**The purpose of the meeting is to formulate the response of Newbury Town Council regarding Planning Application Ref no. 20/01238: Sandleford Park, Newtown Road, Newtown, Newbury for Bloor Homes & Sandleford Farm Partnership.**

## Recommendations to Newbury Town Council and Greenham Parish Council re Planning Application ref. no: 20/01238/OUTMAJ

Sandleford Park, Newtown Road, Newtown, Newbury for Bloor Homes & Sandleford Farm Partnership

## APPENDIX 1.

# Sandleford Ancient Woodlands

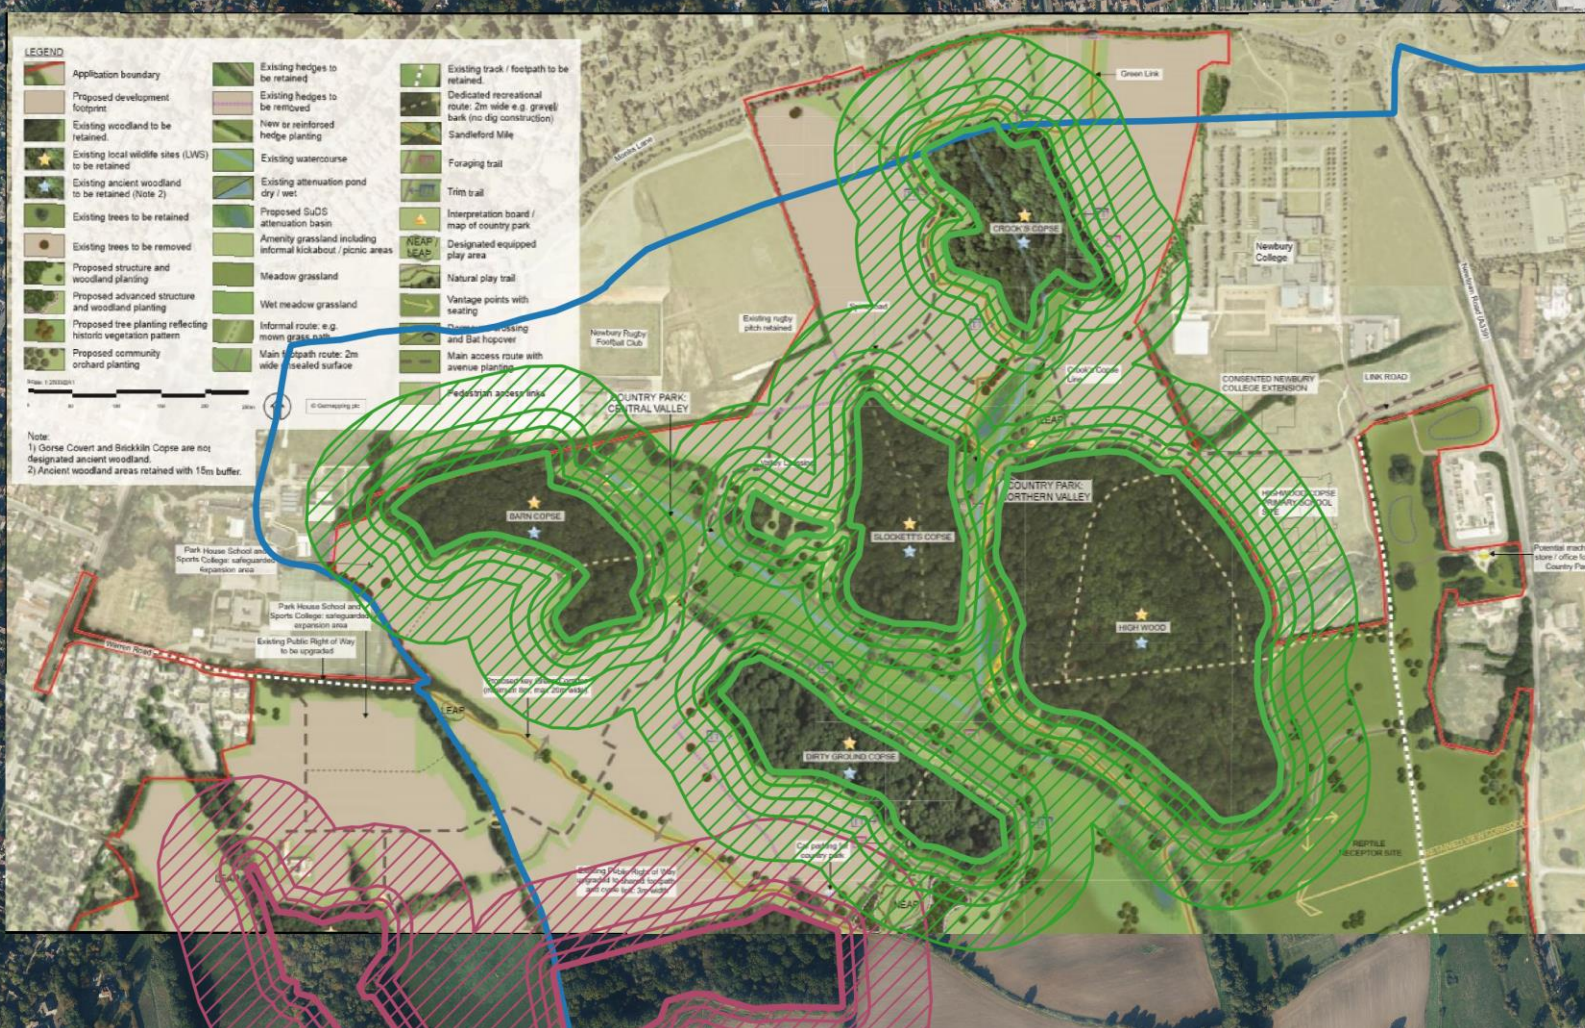
Ancient Woodland circled in green, additional woodlands on site in pink.

**Notes:**  
1) Gorse Covert and Bricklin Copse are not designated ancient woodland.  
2) Ancient woodland areas retained with 15m buffer.

15 metre buffer (NE standing advice minimum)

## 30 metres (BBOWT)

# 50 metres (Woodland Trust)

100 metres

# 100 metres for all woodland

## West Wood, Greenham

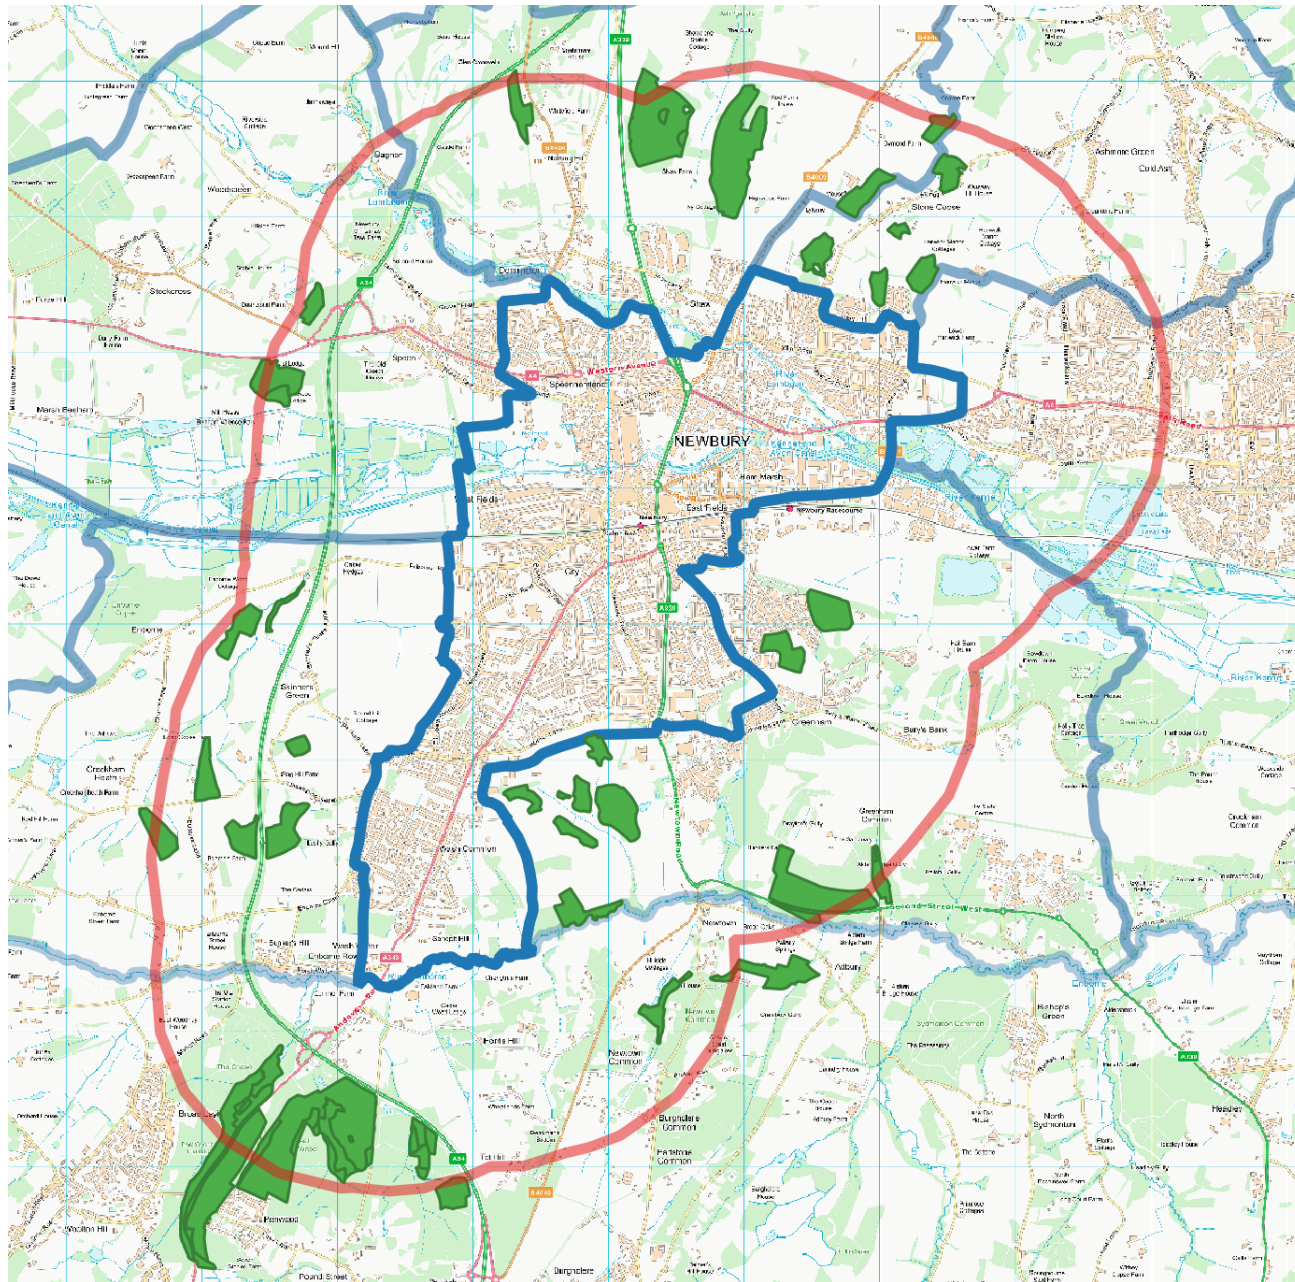
The adjacent new development borders ancient woodland with a 15 metre buffer of apparently poor quality.

## Sandleford 'Green Infrastructure' plan (submitted by Bloor) in context

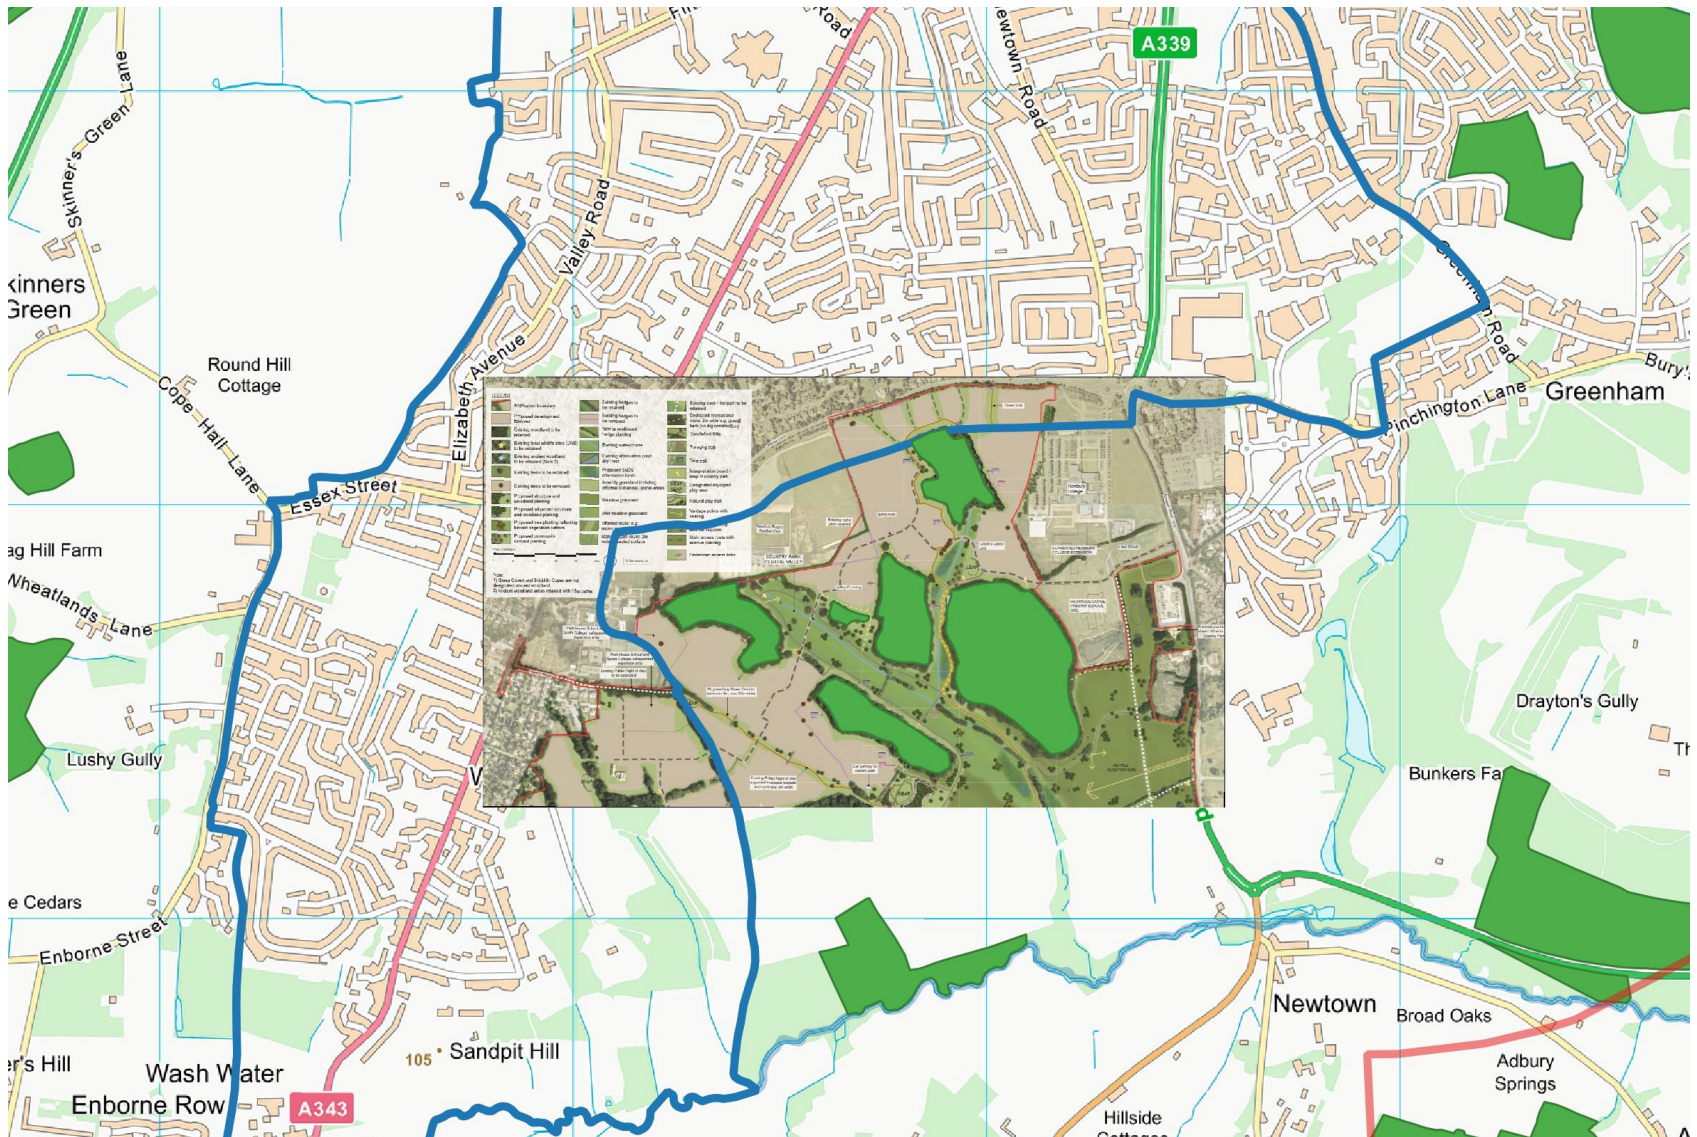
# Newbury ancient woodland network (dark green)
